PUBLIC HEARING MEMORANDUM

Subject: **Petition #39-23** for SPECIAL PERMIT/SITE PLAN APPROVAL for a change of zone to Multi Residence 3 for a parcel of land located at 29 Hunter Street (currently zoned Multi Residence 2), also identified as Section 32, Block 06, Lot 05.

29 Hunter Street

ZONING REVIEW MEMORANDUM

Existing Site Plan

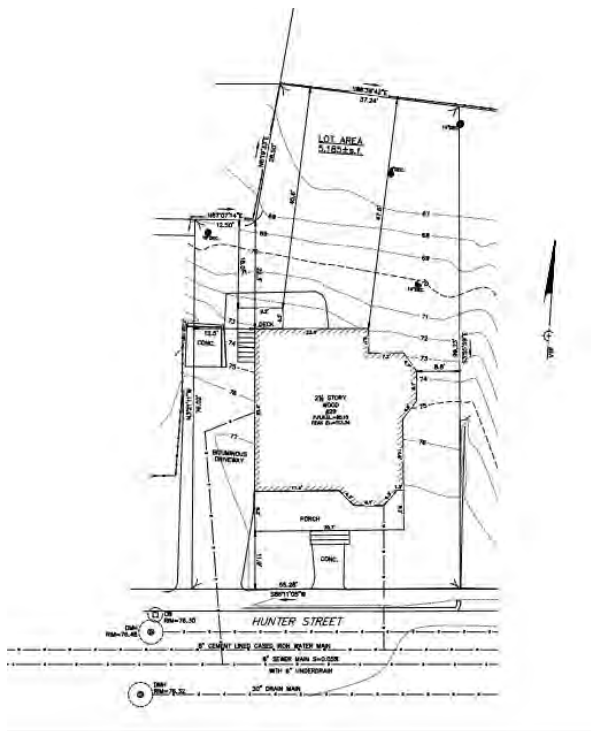
The existing residence has pre-existing nonconforming elements. The front setback is only 11.9 feet, where 25 feet is required for single family dwellings in the MR-2 zoning district. The building height is also nonconforming, at 38.11 feet, where 36 feet is the maximum allowed by right. The frontage on Hunter Street is also nonconforming, at 55 feet where 70 feet is required.

Proposed Site Plan

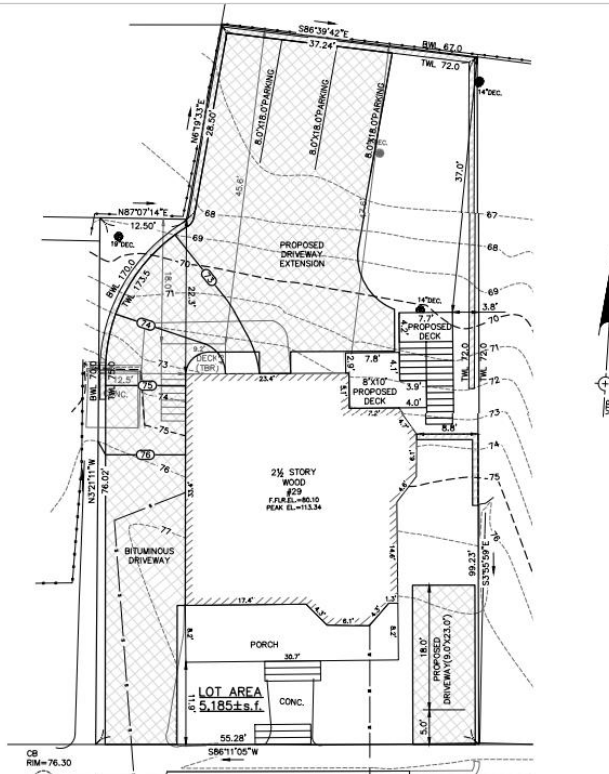
The petitioner is seeking to extend the nonconforming right-side setback by constructing a deck that would be 3.8 feet of the right property line. This would

further reduce the nonconforming side setback to 3.8 feet, requiring a special permit. The series of decks at the rear of the property exacerbates a nonconforming side setback, the applicant should consider reducing the nonconformity and should consider screening from the abutter to the right. No relief is required for the proposed number of stories, lot coverage, open space, or lot area per unit.

The existing driveway will be extended to the rear of the lot with a retaining wall. The retaining wall commences at the property western property line at a height of five feet and curves to the corner of an existing chain link fence, then extends towards the Pike and runs approximately 37 feet. From this point the wall turns 90° and runs parallel to the east property line to meet the existing grade. Along this portion of the wall a set of stairs will provide access from the parking area to a new outdoor deck that will be attached to the existing dwelling. At five feet in height within a setback, the proposed retaining wall requires special permit relief, which the petitioner has not requested. Planning staff have informed the petitioner of this needed relief, and request that the petitioner request the needed relief if they do not intend to revise the design or submit a new plan with a wall at a compliant configuration.

Three parking stalls will be located at the rear of the residence and accessed via the existing curb cut. A second curb cut is proposed on the other side of the home, where the petitioner proposes one parking stall in the front and side setbacks. Two stalls at the rear also lie within the side setback. Because no parking may be located in the front and side setbacks by right, a special permit is required.

Though the lot coverage proposed for this project is compliant at 24.3% where 45% is the maximum allowed, the Planning Department is concerned with the proposed increase in impervious area on the site. The existing impervious area is 2,077 square feet, and is proposed at 3,576 square feet. The majority of this increase is in the driveway paving, which is increasing from 557 square feet to 2,127 square feet. Staff suggest the petitioner consider design alternatives to reduce the amount of impervious driveway paving and eliminate the parking stall within the front setback which results
